## **Economic Commission for Europe**

**Group of Experts on Road Signs and Signals**

**Review of recommendations on A through F signs**

### **Proposal for amendments to Annex 1 and 3**

**DANGEROUS SHOULDERS**

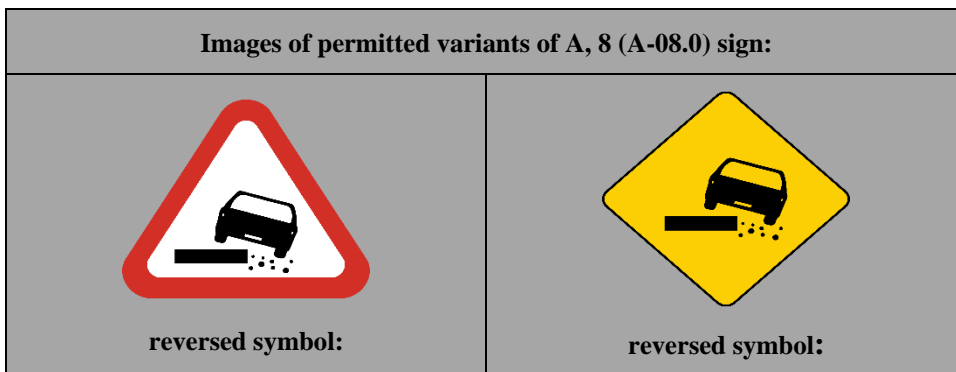
(a) Warning of a section of road where the shoulders are particularly dangerous shall be given by symbol A, 8.

(b) The symbol may be reversed. [ ]

A, 8 (A-08.0) gives warning of a section of road where the shoulders are particularly dangerous. The symbol on this sign may be reversed.

**FALLING ROCKS**

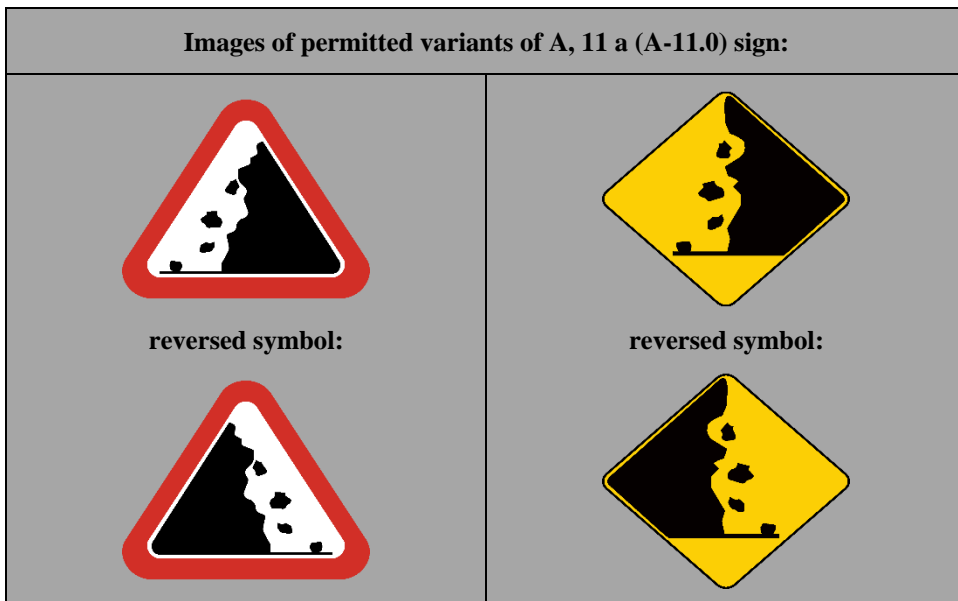
(a) ~~Warning of a section of road on which there is danger from falling rocks and the consequent presence of rocks on the carriageway shall be given by symbol A, 11a used with the sign of model Aa or by symbol A, 11b with the sign of model Ab.~~

(b) ~~The right-hand part of the symbol shall occupy the right-hand corner of the sign panel in both cases.~~

(c) ~~The symbol may be reversed.~~

**A, 11 a (A-11.0) gives warning of a section of road on which there is danger from falling rocks and the consequent presence of rocks on the carriageway. The symbol on this sign may be reversed.**

**PEDESTRIAN CROSSING**

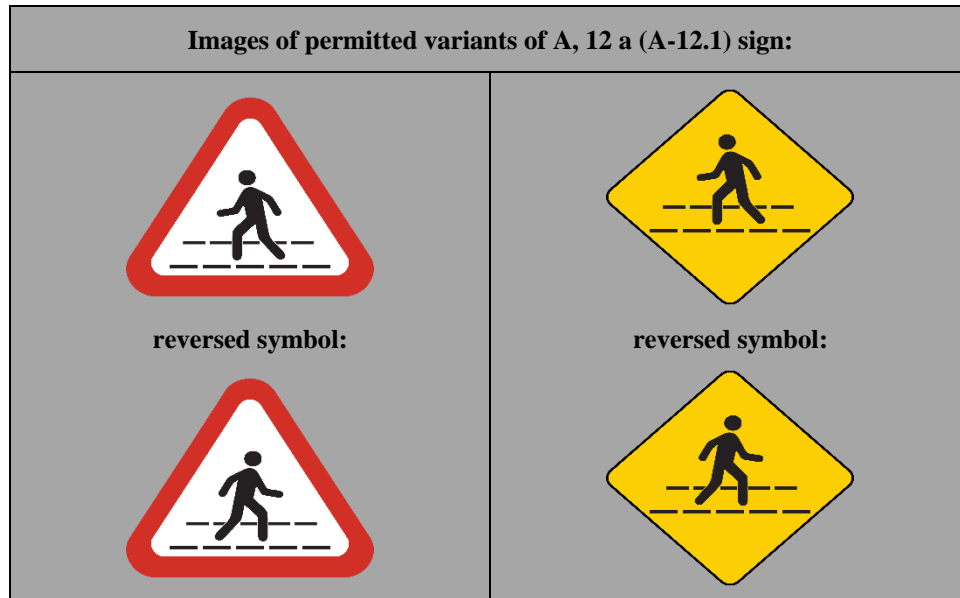
(a) ~~Warning of a pedestrian crossing indicated either by road markings, or by signs E, 12 shall be given by symbol A, 12 of which there are two models: A, 12a and A, 12b.~~

(b) ~~The symbol may be reversed.~~

A, 12 a (A-12.1) gives warning of a pedestrian crossing indicated either by road markings (broken lines), or (and) LW201 LW211 by sign E, 12 a (E-10.1). The symbol on this sign may be reversed.

**DOMESTIC ANIMALS CROSSING**

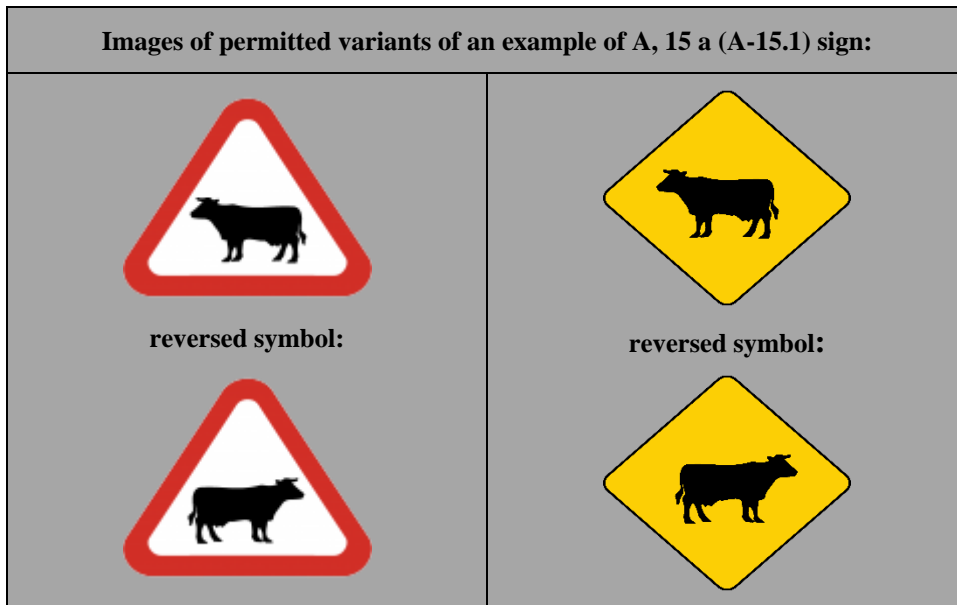
(a) ~~Warning of a section of road on which there is a particular danger of animals crossing shall be given by a symbol representing the silhouette of the animal, domestic or wild, most frequently encountered, such as symbol A, 15a for a domestic animal and symbol A, 15b for a wild animal.~~

**OTHER LEVEL-CROSSINGS**

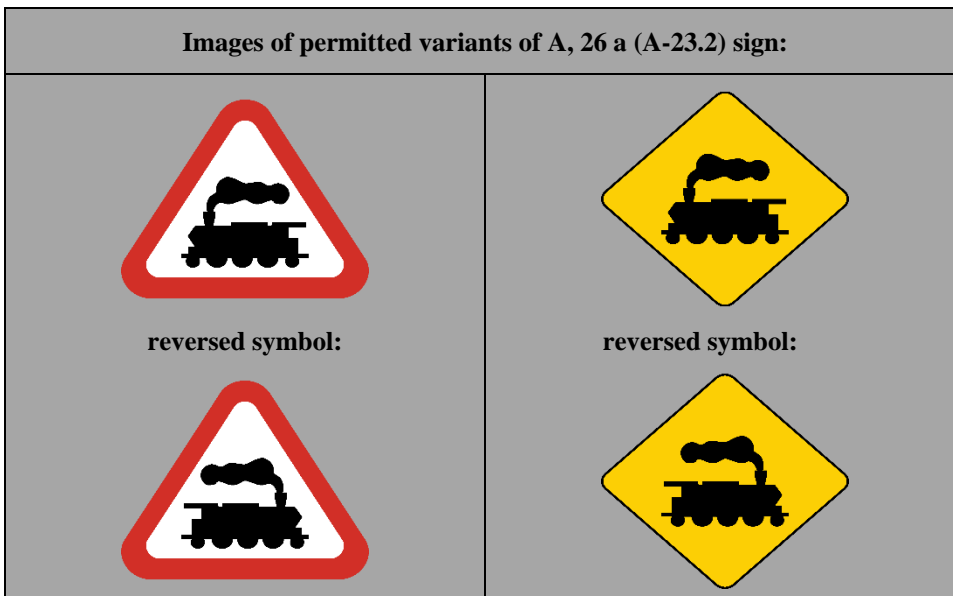
~~Warning of other level crossings shall be given by symbol A, 26 a or A, 26 b, or by symbol A, 27 as appropriate.~~

**STOP SIGN**

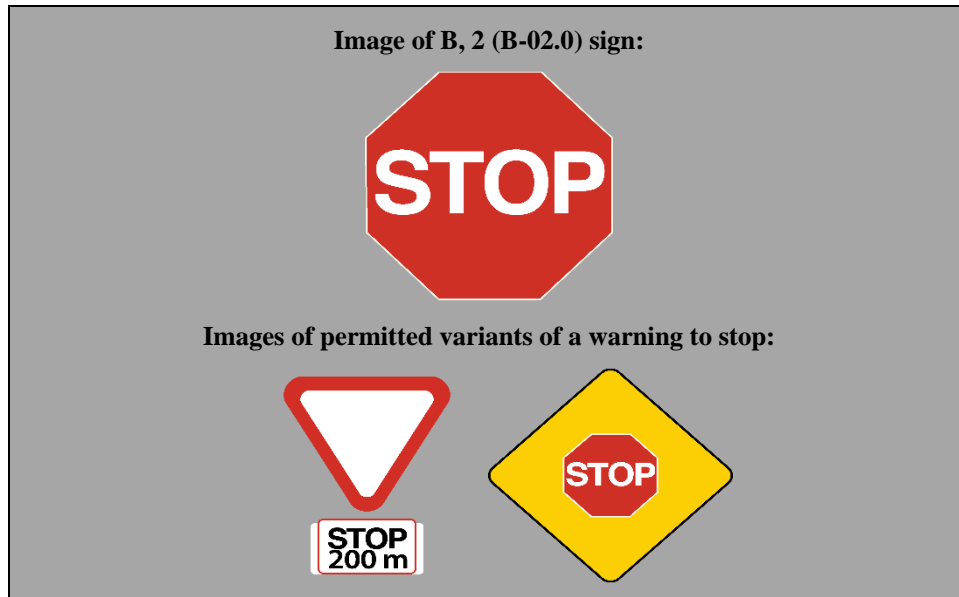
B, 2 (B-02.0) notifies ~~road users~~ drivers ~~that, at the intersection where the sign is placed, they must stop before entering the intersection and give way to vehicles on the road they are approaching.~~ It is an octagon with a red ground surrounded by a white rim and bears the "STOP" inscription in white in English or in the language of the State concerned. The height of the inscription shall be no less than one third of the height of the panel.

**PRIORITY OVER ONCOMING TRAFFIC**

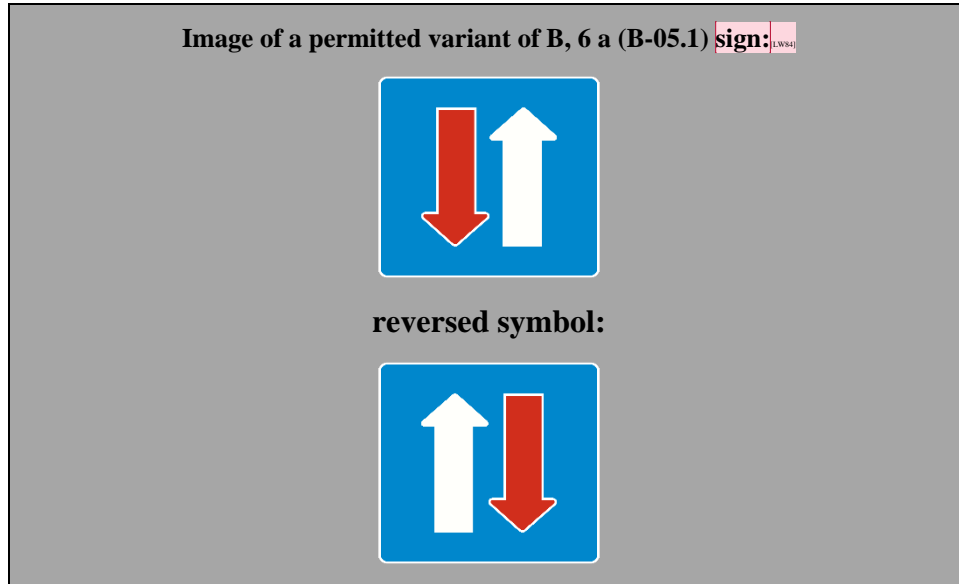
~~(a) To notify drivers that on a narrow section of road they have priority over oncoming vehicles the sign used shall be B, 6.~~

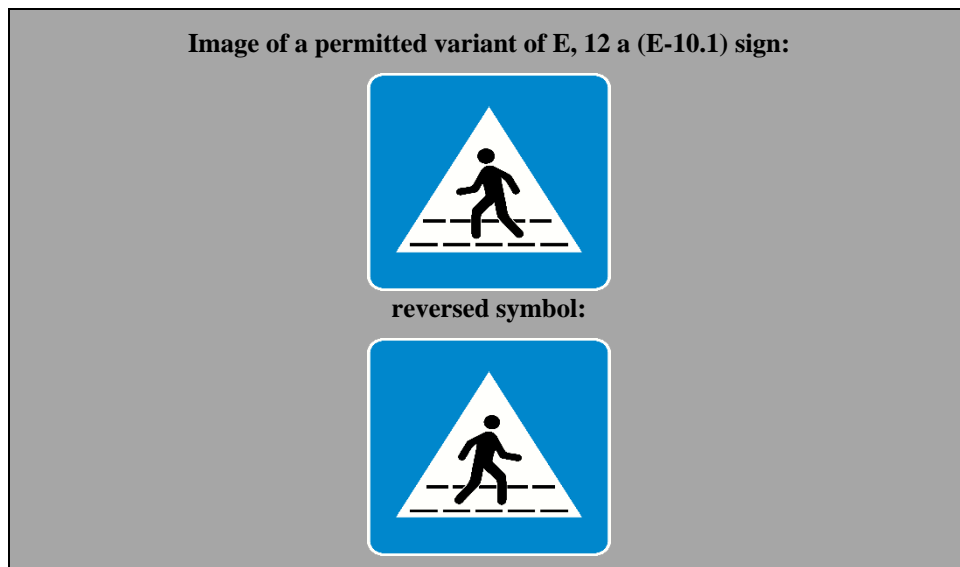
(a) Sign E, 12 a (E-10.1) "PEDESTRIAN CROSSING", notifies road users of is used to show pedestrians and drivers the position of a pedestrian crossing. The ground of the panel this sign shall be blue or black with the triangle a white or yellow triangle. and the symbol shall be black or dark blue. the This symbol shall symbol displayed shall be a pedestrian on a crossing marked by broken lines. symbol as A, 12 a (A-12.1). The symbol on this sign may be reversed.

**FILLING STATION**

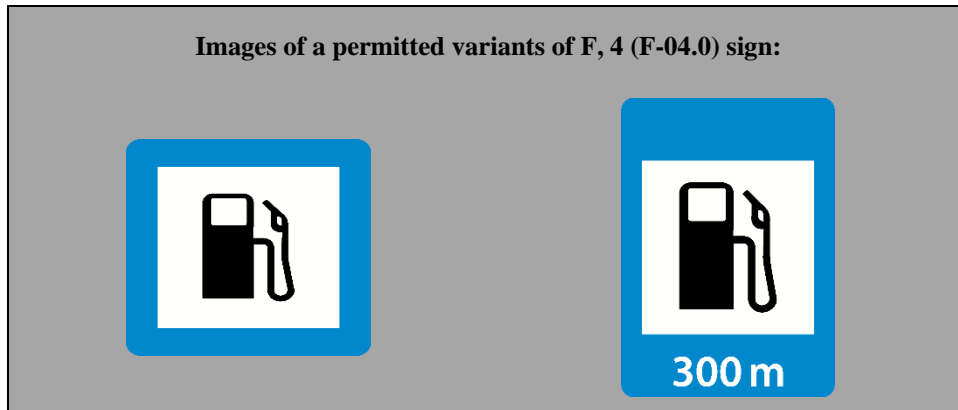
F, 4 (F-04.0) "~~FILLING STATION~~" indicates a placement of a filling station

#### HOTEL OR MOTEL

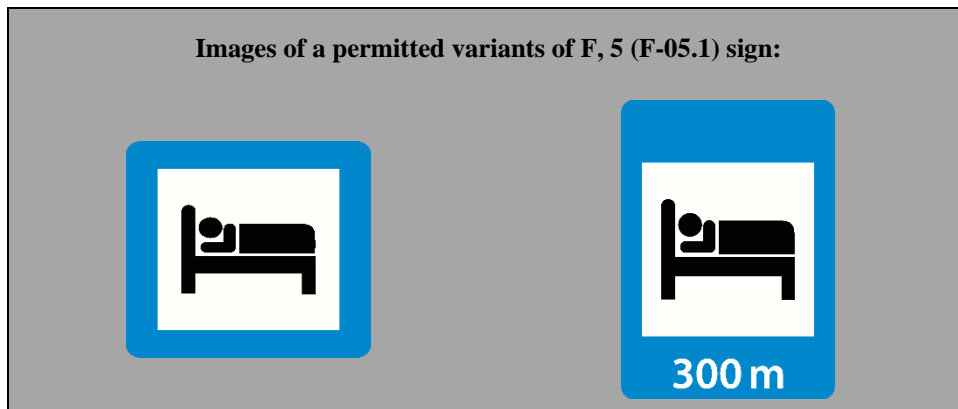
F, 5 (F-05.1) "~~HOTEL or MOTEL~~" indicates a placement of a hotel or motel. This sign - the variant with inscription – may contain the inscription "HOTEL" or "MOTEL" in white on the bottom blue or green ground.

#### YOUTH HOSTEL

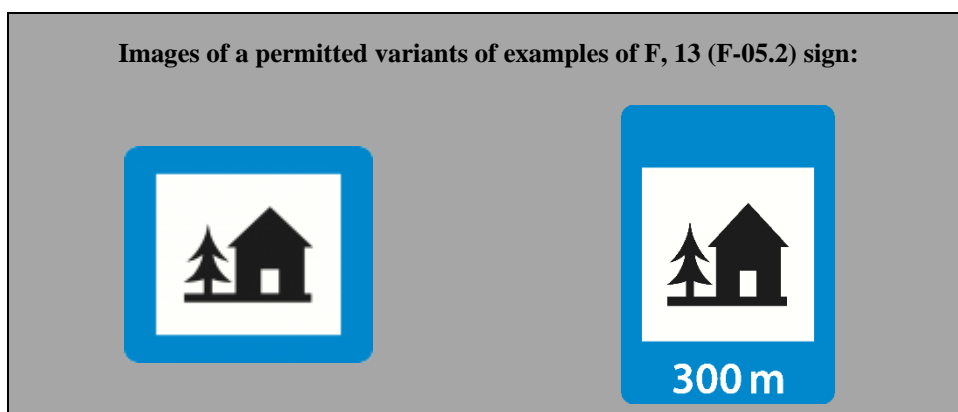
F, 13 (F-05.2) "~~YOUTH HOSTEL~~" indicates a placement of a youth hostel.

#### RESTAURANT

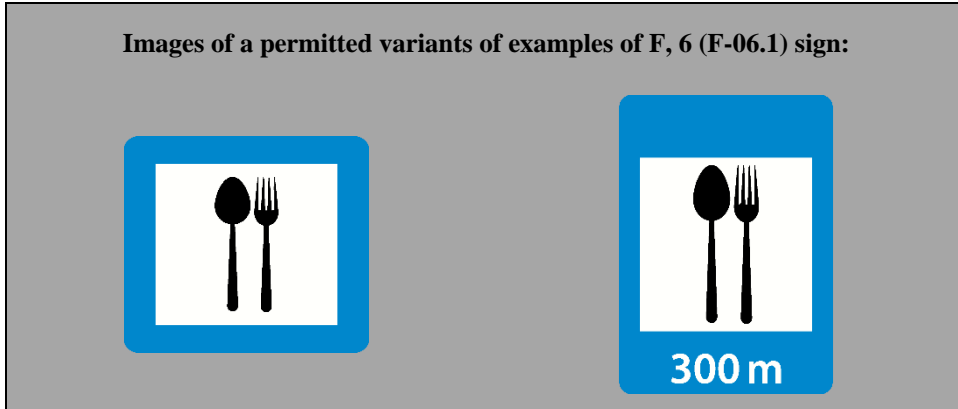
F, 6 (F-06.1) "~~RESTAURANT~~" indicates a placement of a restaurant.

**REFRESHMENTS OR CAFETERIA**

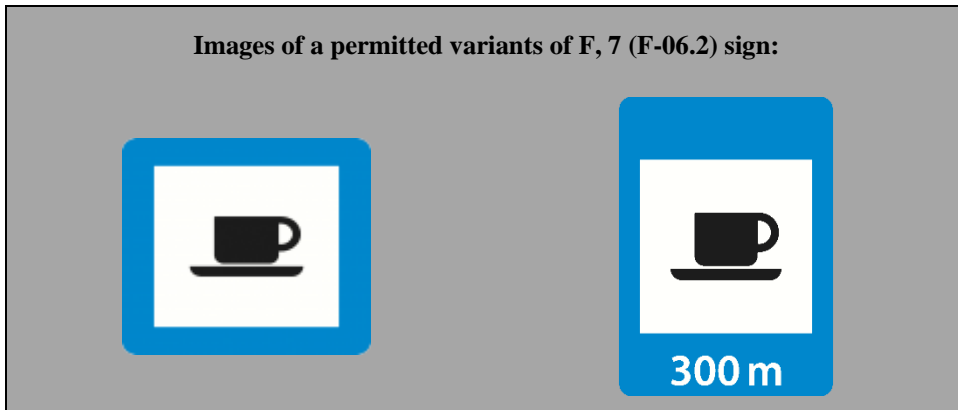
F, 7 (F-06.2) "~~REFRESHMENTS OR CAFETERIA~~" indicates an availability of refreshments or a cafeteria.

**PICNIC SITE ~~OR REST AREA~~**

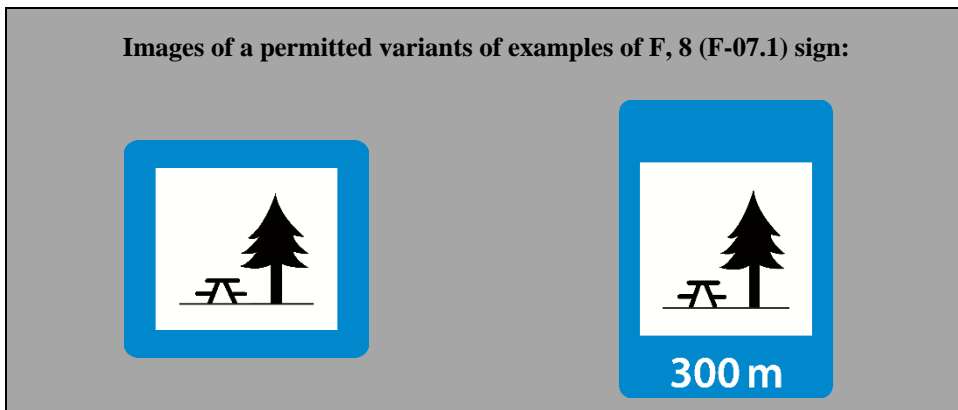
F, 8 (F-07.1) "~~PICNIC SITE~~" indicates a placement of a picnic site

**CAMPING SITE**

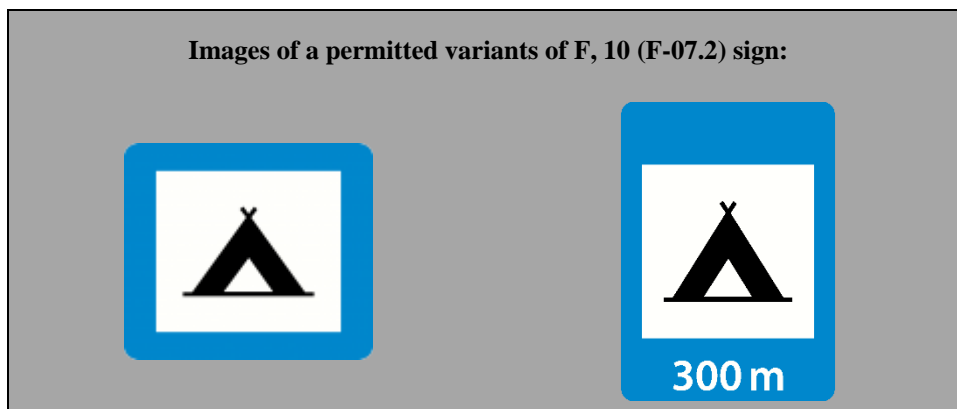
F, 10 (F-07.2) "~~CAMPING SITE~~" indicates a placement of a camping site.

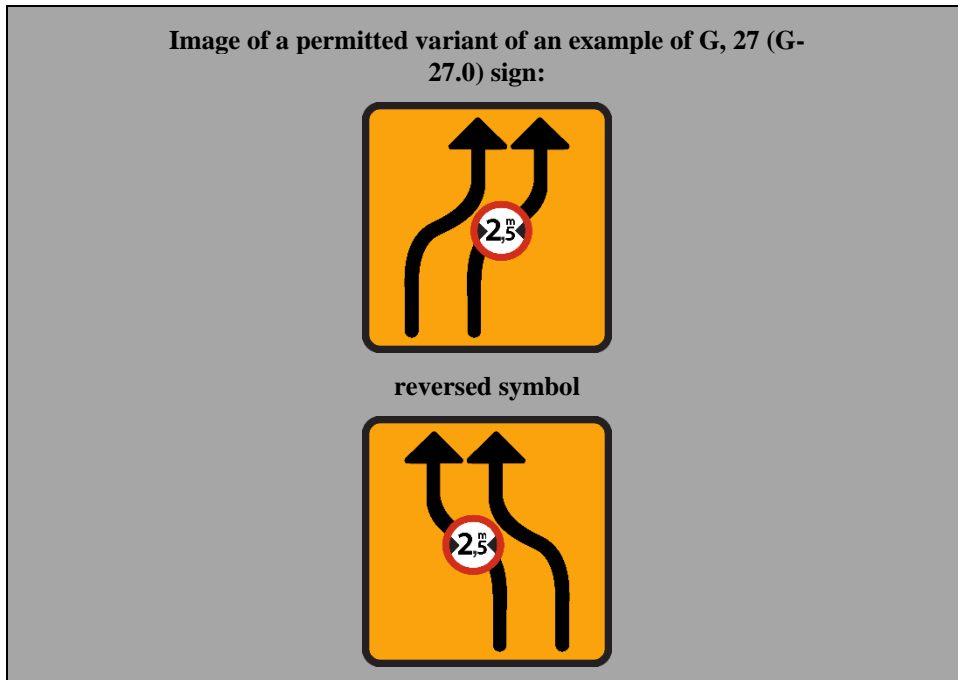
G, 27 (G-27.0) ~~a and G, 27 b are examples of signs showing~~ indicates direction of traffic lanes during road works. The symbol may be reversed.

**TEMPORARY LANE CLOSURE**

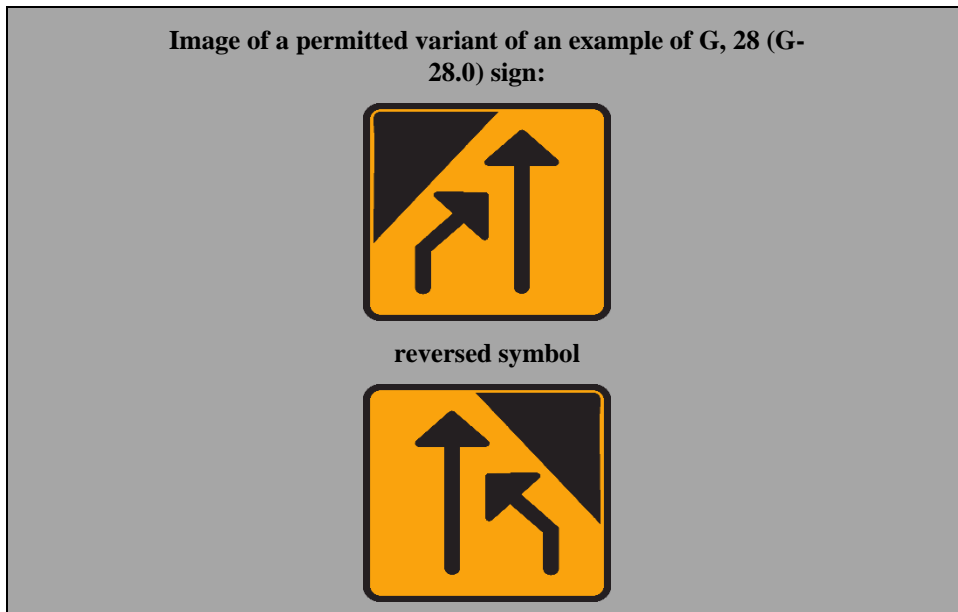
G, 28 (G-28.0) is an example showing indicates a temporary closure of a lane. The symbol on this sign may be reversed.
